Travelodge, Great Ducie Street, Manchester, M3 1RR

**Application for Non Material Amendment (NMA) under Section 96A of TCPA 1990 for:
Amendments to External Cladding of Building**

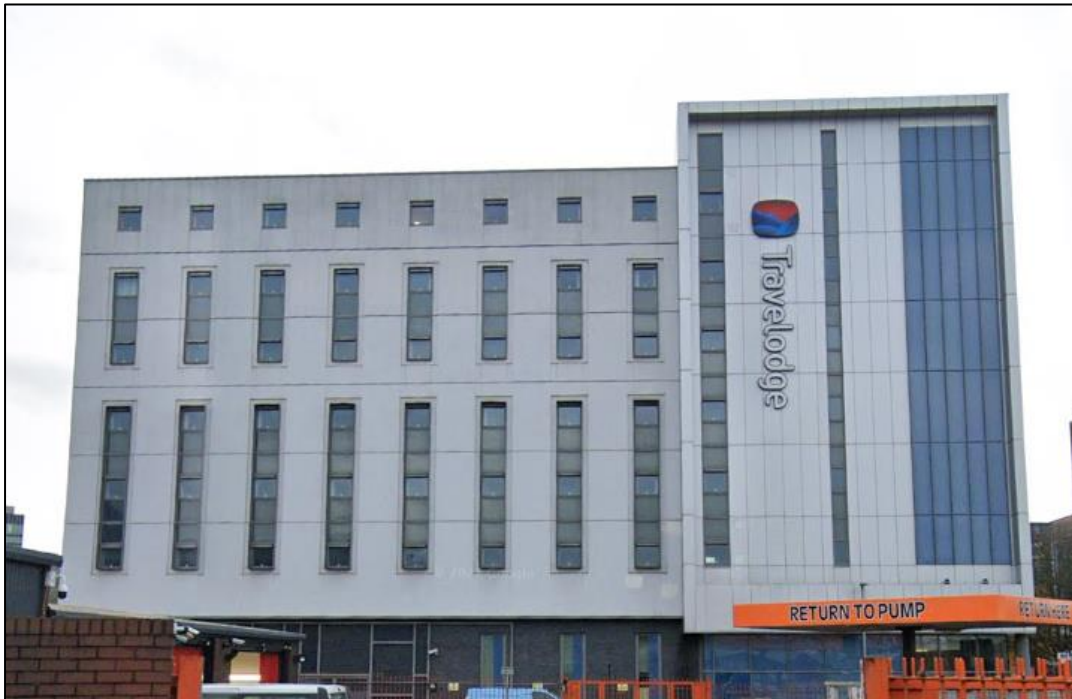
- Aluminium Composite Material (ACM) cladding in grey.
- Standing seam metal cladding in light grey/silver.
- Glass rainscreen cladding in blue/grey.
- Through colour render in off white.
